BLANCHARD LETENDRE
ENGINEERING

Our File Reference No: 23-172

SUBJECT: 2ND REVIEW COMMENTS
PROJECT ADDRESS: 1274 MARYGROVE CIRCLE
PERMIT NUMBER: FILE # D02-02-23-0016
REPORT TYPE: ENGINEERING BRIEF

Catchment Map

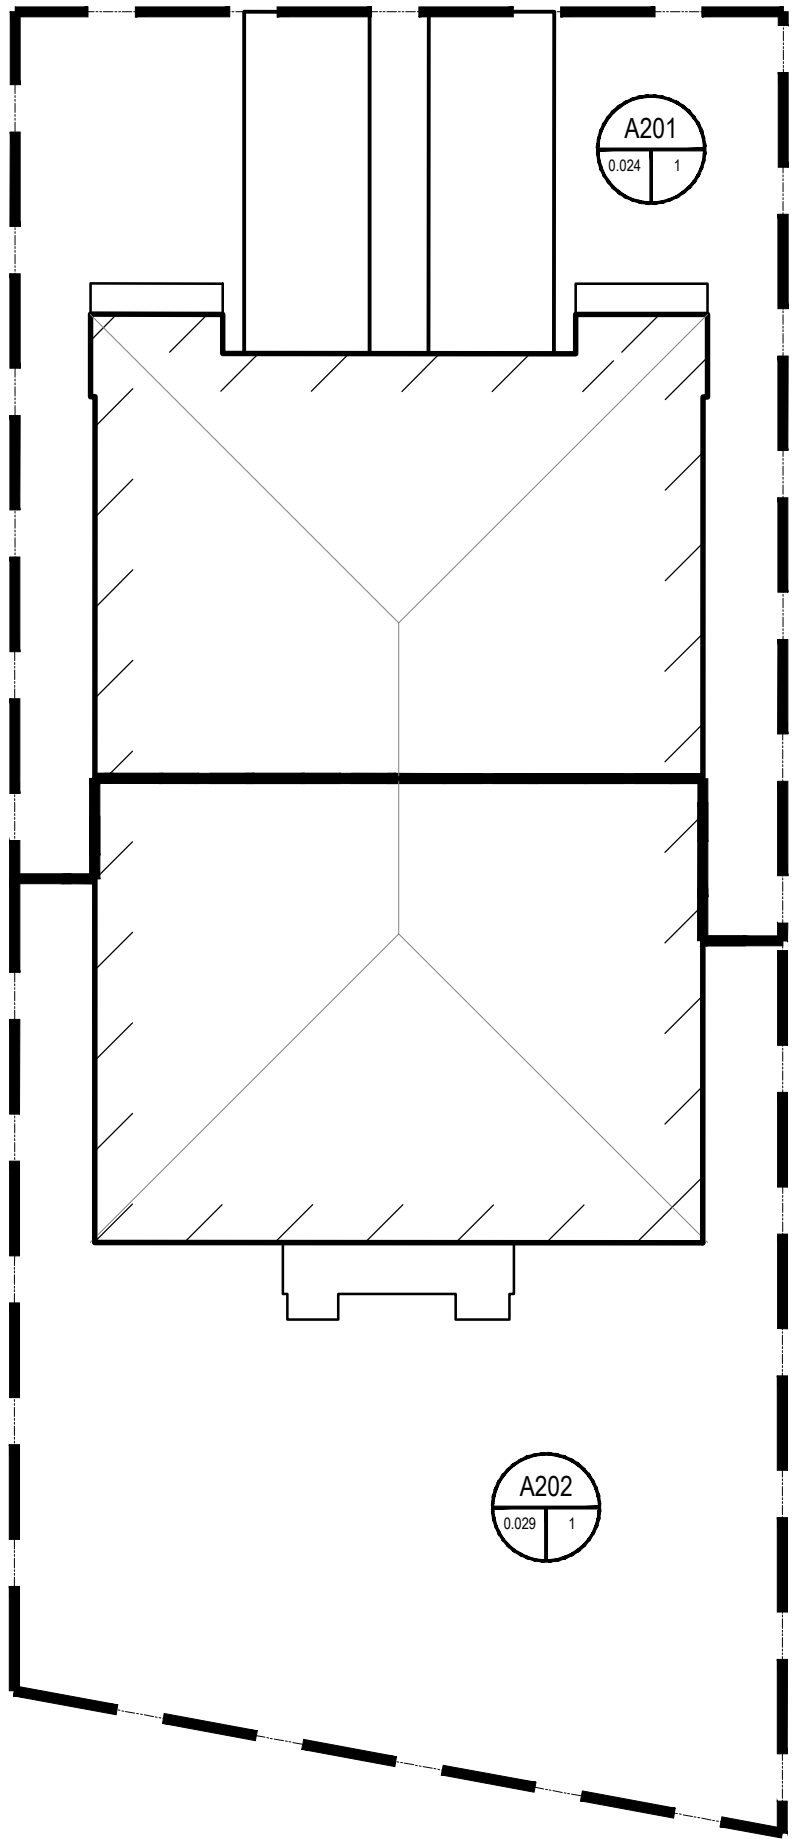
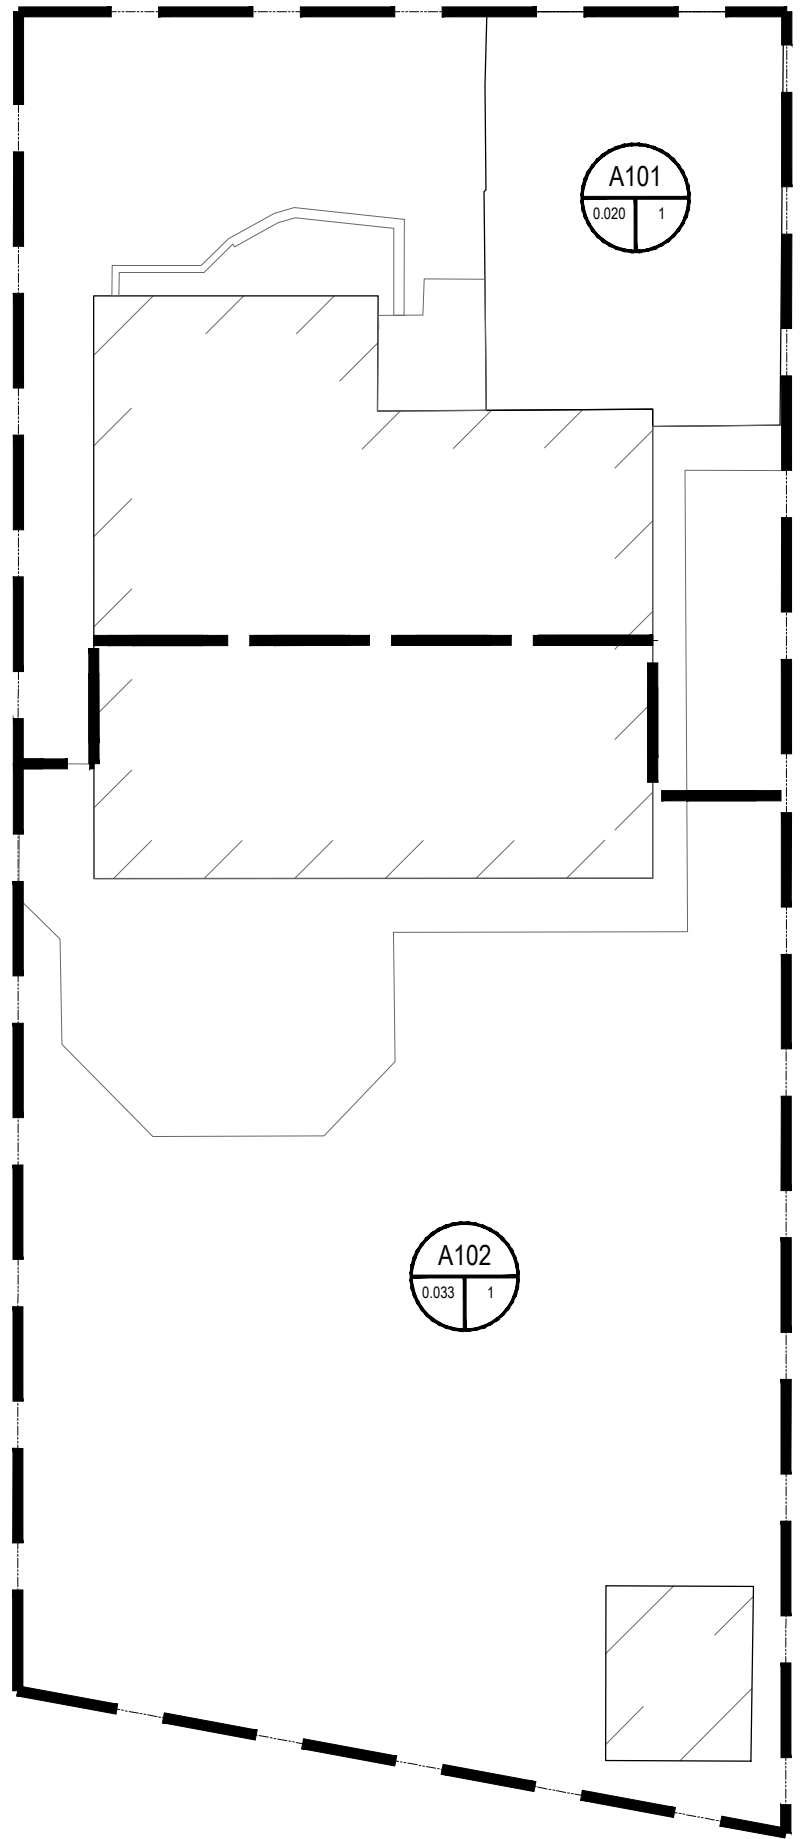
"1.7. The section should discuss the increase in imperviousness. The drainage conveyance methods. How impact to neighbouring properties would be reduced (i.e. roof drains only drain to the street/etc). A drainage sub-catchment plan is helpful.

(City 2023): Outstanding. Excess drainage cannot be directed to neighbouring properties. The stormwater management section must include information on the existing site condition and the changes as a result of the proposal along with mitigation measures. Are there existing drainage issues such as ponding/poor grading etc?"

(LBE Jul 2023): The report has been revised to make general statements on the proposed change in imperviousness, how it is proposed to be graded and drained (by others) A drainage sub-catchment plan is not available, however the grading plan is, from which this information can be inferred.

The proposed development will result in a small net decrease in uncontrolled run-off to the rear property lines as a result of this development, while there will be a small net increase in uncontrolled run-off to the City ROW.

The uncontrolled area to the rear maintains a typical assumed weighted run-off coefficient of C=0.5 for infill development. This is not anticipated to have any impacts to downstream infrastructure.

The extent of existing topography available suggests that the existing overland flow for rear drainage occurs in the overhead utility easement. The flow direction is southward.
